# Petition No. RZ 201403068 and CV 201403069

# DEPARTMENT OF COMMUNITY DEVELOPMENT RECOMMENDATION RZ 201403068 - Approval and CV 201403069 - Approval

### SITE PLAN ANALYSIS FOR THE UDC ZONING

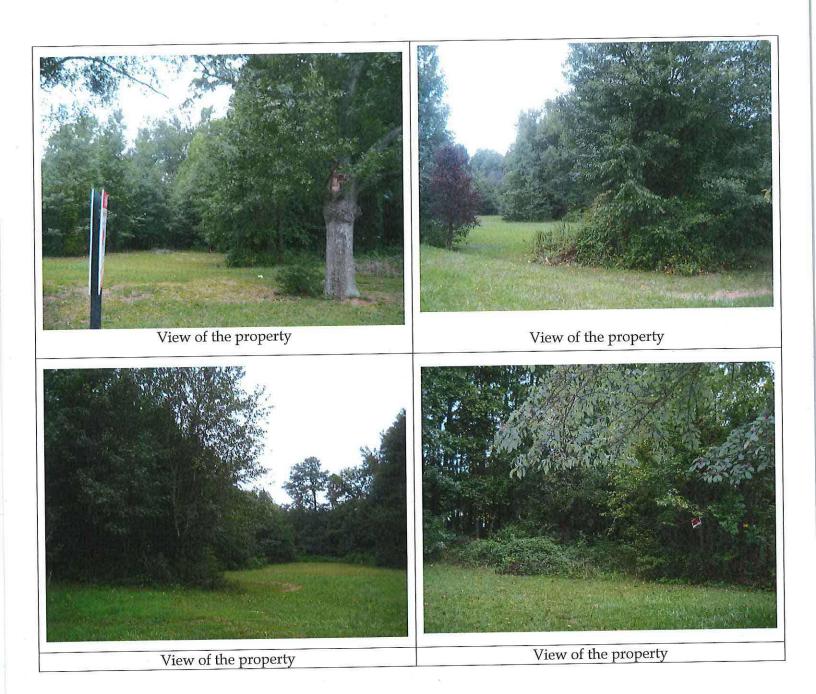
The proposed site plan indicates a 19, 800 SF building with play yards. They are indicating a Type C buffer abutting the RTH property which will also need to have an 8' wall along the property line as a part of the buffer. The amenity space on the site exceeds the required 20%. The required parking for the site is 39 spaces. The proposed site plan indicates 38 vehicular parking spaces with 2 motorcycle parking spaces and four bicycle spaces.

- Architectural comments related to the building and roofline.
- 2. With the right tweaks to the architecture and site plan in terms of view obscuration and proper landscaping, the plan could be implemented.

# DEPARTMENT COMMENTS · Approval of the plan does not imply approval of the stormwater solution that is City of Roswell Environmental proposed. Department • A land disturbance permit will be required. Design plan and construction shall comply with the city standard construction specifications. · Access to sanitary sewer appears to require an offsite easement. Show sanitary City of Roswell sewer connection point. Engineering • Onsite well must be abandoned per state requirements prior to the issuance of the LDP. • A fire flow test in accordance with the International Fire Code – 2012 Edition, appendix B is required. The test must include a 24 static pressure test to determine the lowest available amount of water. The existing and proposed City of Roswell Fire Department water hydrants must be calculated based on the 24 static test to determine the total GPM available in each hydrants 20 PSI residual pressure. All of this test documentation must be included on the land disturbance plans. · Consider vehicular connectivity to adjacent parcel on the west (Express Oil Change). ADA ramps shall be provided on both sides of Roswell Commons at Mansell Road intersection. Sidewalk must be provided along the entire Mansell Road and Roswell Commons Circle frontages. • Provide sidewalk connectivity to the proposed building. • Provide ingress and egress (drive length) of a minimum of 25' at the proposed drives along Mansell Road and Roswell Commons Circle. The ingress/egress

• The minimum tangent curb length between the driveway radius of the proposed access on Roswell Commons Circle and Mansell Road intersection must be a minimum of 100 feet. (section 2.1.6 paragraph 8 of the COR).

- Right-of-way at Mansell Road and Roswell Commons Circle intersection shall be mitered a minimum of 20 feet or parallel the back of curb, per the City of Roswell Code.
- The right-of-way at Mansell Road and Roswell Commons Circle must encompass the proposed sidewalk and ADA ramps plus a minimum of one foot. Label the right-of-way, existing and proposed distances from Mansell Road and Roswell Commons Circle centerline along the site frontage.
- Label radii of the proposed driveways on Mansell Road and Roswell Commons Circle. The two proposed driveway radii must be not less than 30' or more than 50'.
- Miter the ROW a minimum of 20 feet at the two proposed driveways and at Mansell Road and Roswell Commons Circle intersection.
- · Maintenance bond is required prior to Land Disturbance Permit, if amount of

• Must provide 4 inch caliper trees to recompense the 12 specimen density units to be removed, see UDC section 12.1.3 B-4 Credit for Planting Trees.

Revised plan submitted – October 7, 2014 – made changes due to comments from staff; added proposed right-of-way at the right-in/right-out entrance on Mansell Road and at the intersection of Mansell Road and Roswell Commons Circle, changed a 6' sidewalk to 5' sidewalk to allow for the 1' from back of curb and added the 25' radius returns.
